**Re: C.F. Nos. 22-0922-S1 and 22-0922-S2; 650-676 S. San Vicente Blvd.;
Case Nos. CPC-2017-467-GPA-VZC-HD-SPR-1A and VTT-74865-1A;
ENV-2017-468-EIR (SCH No. 2020010172)**

B. Parking Plans Violate the LAMC

1. *Parking Lifts Improperly Utilize Tandem Parking*

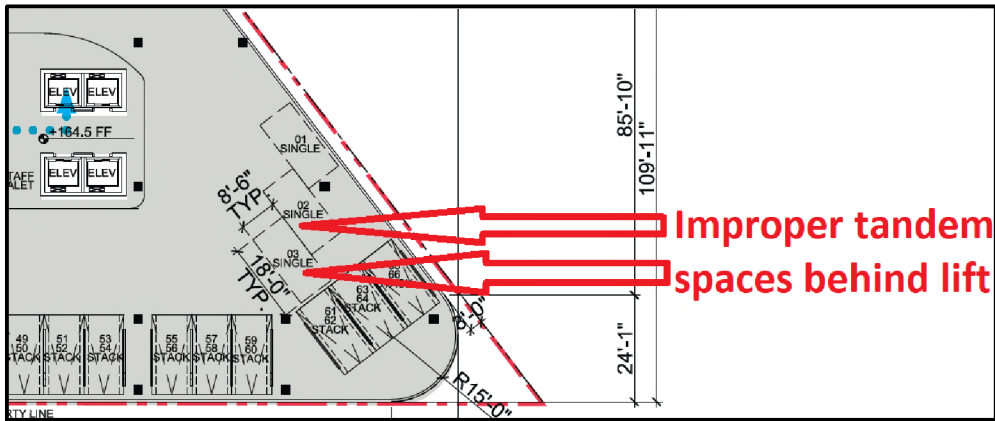
LAMC Section 12.21-A.4(h) requires that all required parking spaces shall be accessible. The Superintendent of Building has published the Parking Design Bulletin (**Exhibit 1**) to clarify the meaning of accessibility in the context of tandem and stacked parking.

2. Parking Lifts Fail to Provide Required Aisle Width

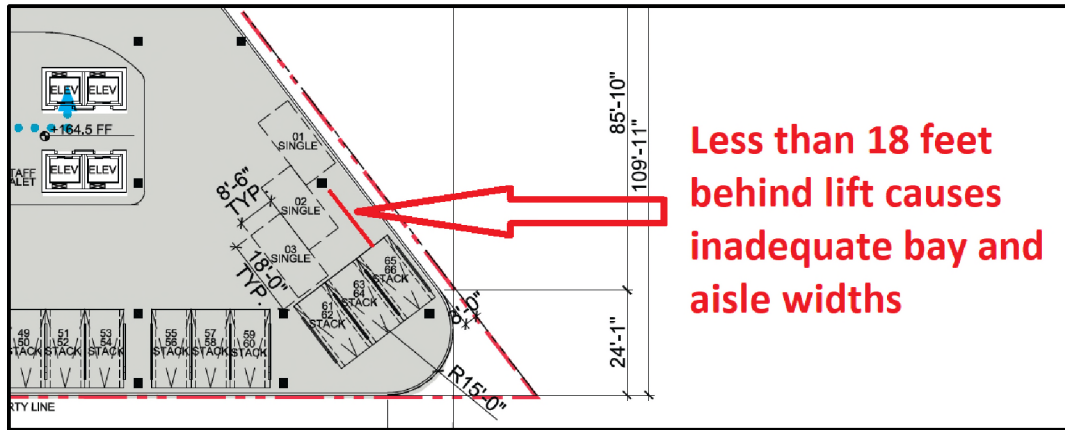
LAMC Section 12.21-A.5 establishes parking design standards, including graphs plotting minimum bay and aisle widths for parking areas based on the angle of parking. The LADBS Parking Design Bulletin clarifies the dimensions on these graphs to specify the precise widths required for various parking configurations. As noted above, the Parking Design Bulletin requires that the platform on the mechanical lift shall meet the standards in LAMC Sections 12.21-A.5(a) (Bay Dimensions) and 12.21-A.5(b) (Aisle Dimensions). Table 4 establishes minimum bay widths between 42 feet and 46 feet for standard parking stalls installed at 90 degrees to the aisle. Table 6 requires minimum aisle widths of 20' for compact commercial parking stalls and 22' for standard commercial parking stalls installed at 90 degrees to the aisle.

The Project fails to comply with these standards because parking lifts on the southern corner of the parking levels have inadequate bay and aisle widths. Based on the dimensions shown on the plans, the aisle width is less than 18 feet because there is a structural column located immediately behind the lifts. This results in a bay width of less than 36 feet, adding the 18 foot depth of each stall to the distance between the lift and the structural column, which is less than 18 feet. Thus, the lifts on each level are noncompliant with the LAMC and the parking spaces cannot count as required parking spaces. This noncompliance is illustrated below:

H. The Project Exceeds its Requested FAR After Required Dedications are Provided

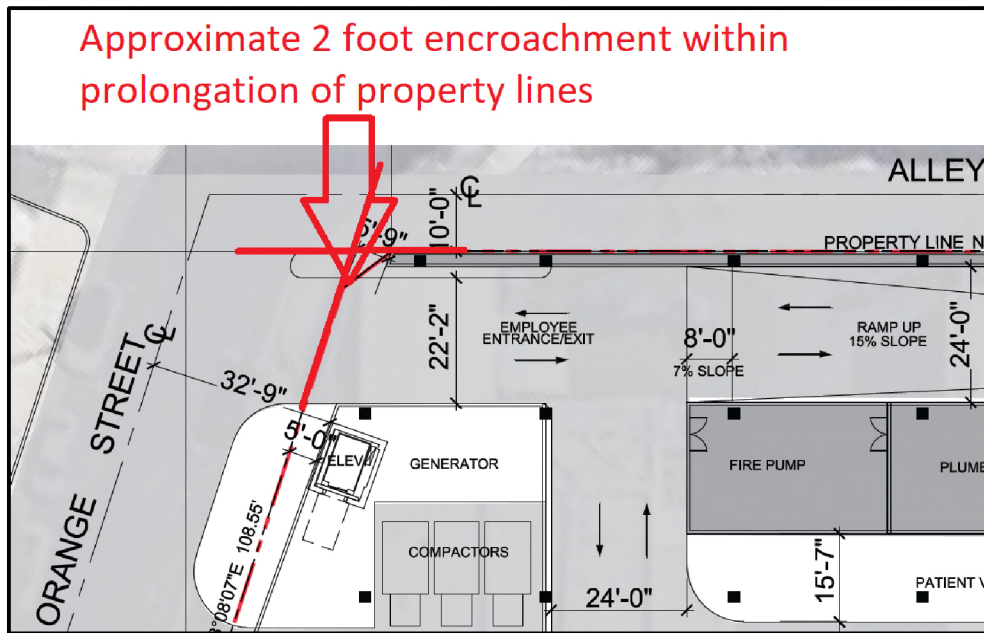
LAMC Section 12.37-G requires that the FAR of a Project is calculated from the net lot area after accounting for all required dedications. The City Planning Commission approved a Zone and Height District Change to permit a maximum FAR of 4.5 to 1, permitting 145,305 square feet of Floor Area on a site with a net area after dedications of 32,290 square feet. The required dedications on San Vicente Boulevard would reduce the lot area by approximately 3,253 square feet,⁴ resulting in a net lot area of 29,037 square feet. An FAR of 4.5 to 1 on this net lot area would permit a maximum of 130,666 square feet of Floor Area, or 14,638 square feet less than proposed. The Project's proposed 145,305 square feet of Floor Area on a 29,037 square foot net lot area would yield an FAR exceeding 5 to 1. The City Council lacks authority to approve an FAR materially greater than that requested in the application and approved by the City Planning Commission. Approval of a greater FAR than described in the DEIR would also result in a fatally inaccurate Project Description in violation of CEQA.
